15/00619/FUL- South West Milton Keynes

Rebuttal Proof of Evidence -
Highways / Transportation

Doc ref: 16414-HYD-XX-XX-RP-TP-0009

Figure 2.1: DMRB CD116¹⁷ Geometric Design of Roundabouts Figure 3.39 - measurement of Stopping Sight Distance on roundabout approach

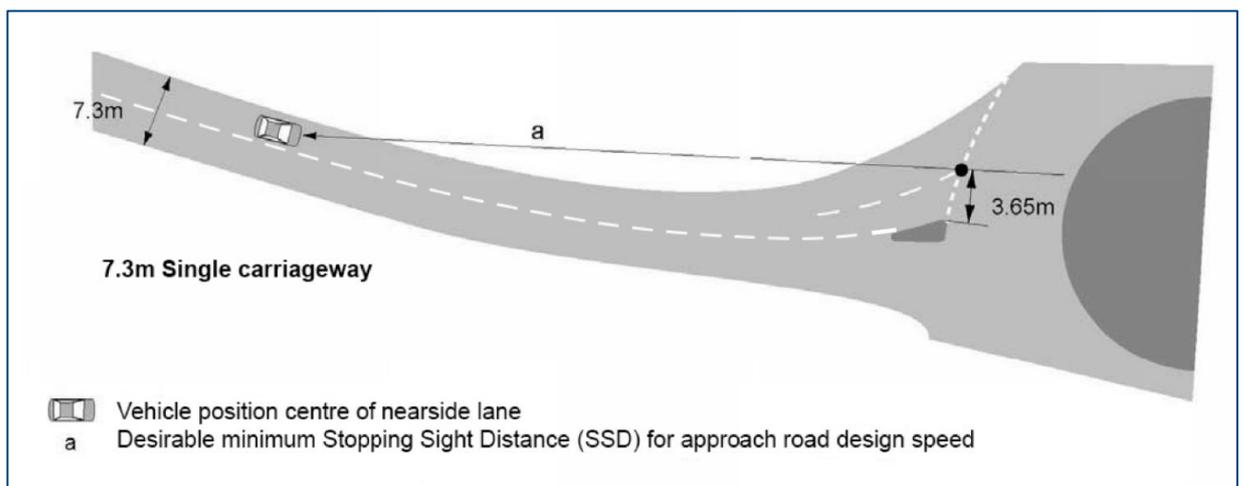
- 2.4.7 Figure 4.6 of Mr Paddle's proof of evidence¹⁶ erroneously shows the forward-visibility onto the roundabout from the centreline of the Buckingham Road (east) approach. The measurement should be taken from the centre of the approach lane (not the carriageway centreline), as shown in Figure 2.1:

2.4.8 It can be seen that, on this basis, the 160m visibility splay indicated by Mr Paddle cannot be achieved without the requirement for third-party land (part of the property known as New Leys).

Figure 2.4: Extent of area considered in TA/TRNs (MJP14⁴⁷ Figure 2-1)

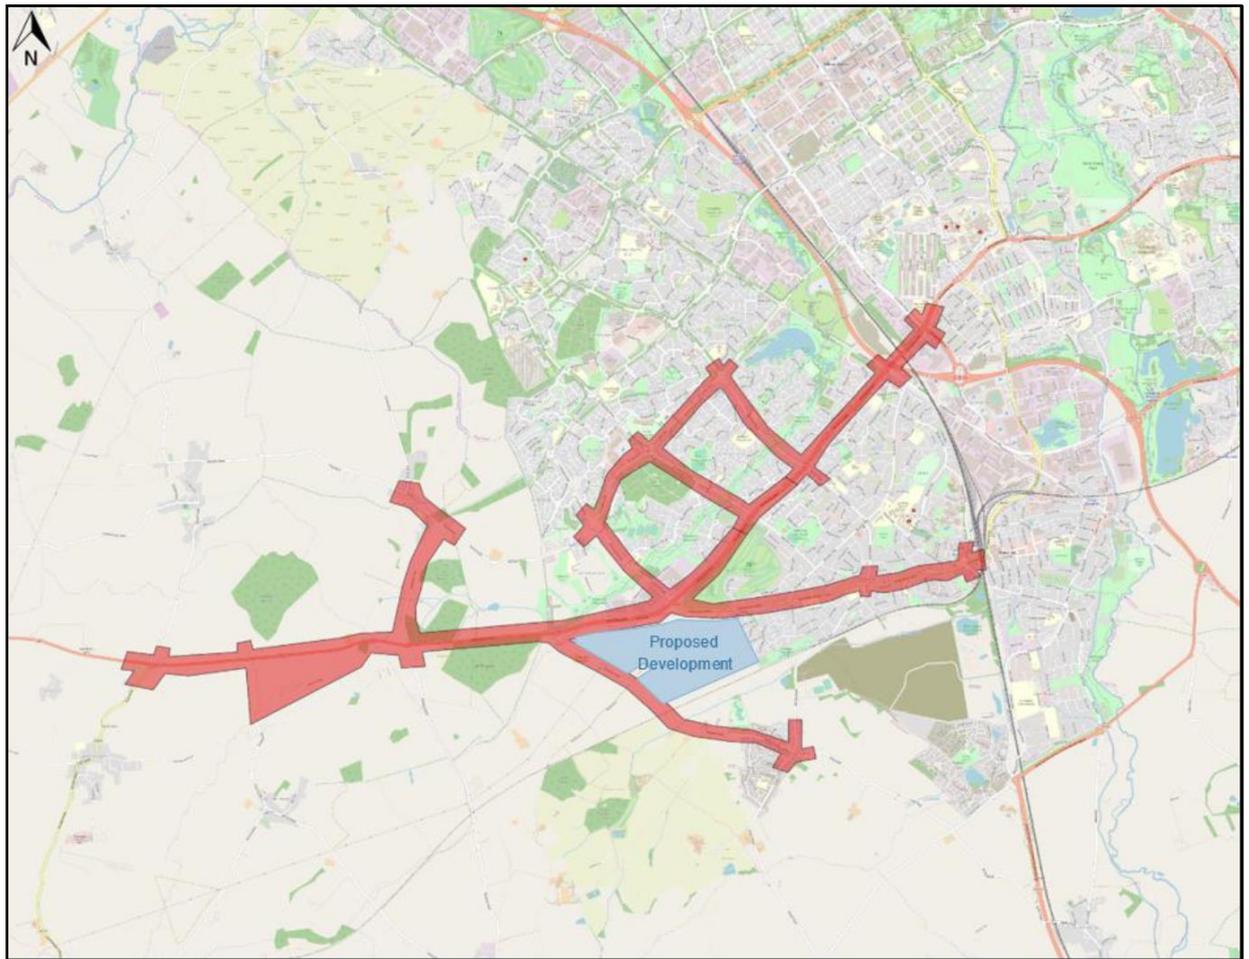
- 2.6.5 Mr Paddle's proof accepts that as a consequence of the proposed development there is the potential for vehicles to reassign across a 'very large' area (2.2⁴¹). Residential accesses and other smaller roads 'would be potential alternative routes for traffic' (2.3⁴¹). The minimum area which WSP considers could be subject to traffic reassignment is shown in Figure 2.3, and the area considered in the 2020 TA³⁷ / subsequent TRNs⁴⁵ is shown for comparison in Figure 2.4.

- 2.6.6 WSP argues that data requirements (2.5⁴⁷) and the need for junction-specific modelling (2.14⁴⁷) mean that microsimulation is an inappropriate approach in this case. However, the same data is required in relation to SATURN or VISUM modelling, as used by the appellant in its 2016 TA⁴⁸. Indeed, WSP states that alternative approaches (such as SATURN or VISUM)⁴⁹ may be required in order to achieve a realistic and viable model⁵⁰.
- 2.6.7 Furthermore, the methods of data collection set out in MJP14⁴⁷ are not the only options available to the appellant. For example, alternative means of data collection could include mobile phone data (for O-D), Google API (for journey times) and other existing data (e.g. DfT counters, ATC/MCC data already in the public domain).
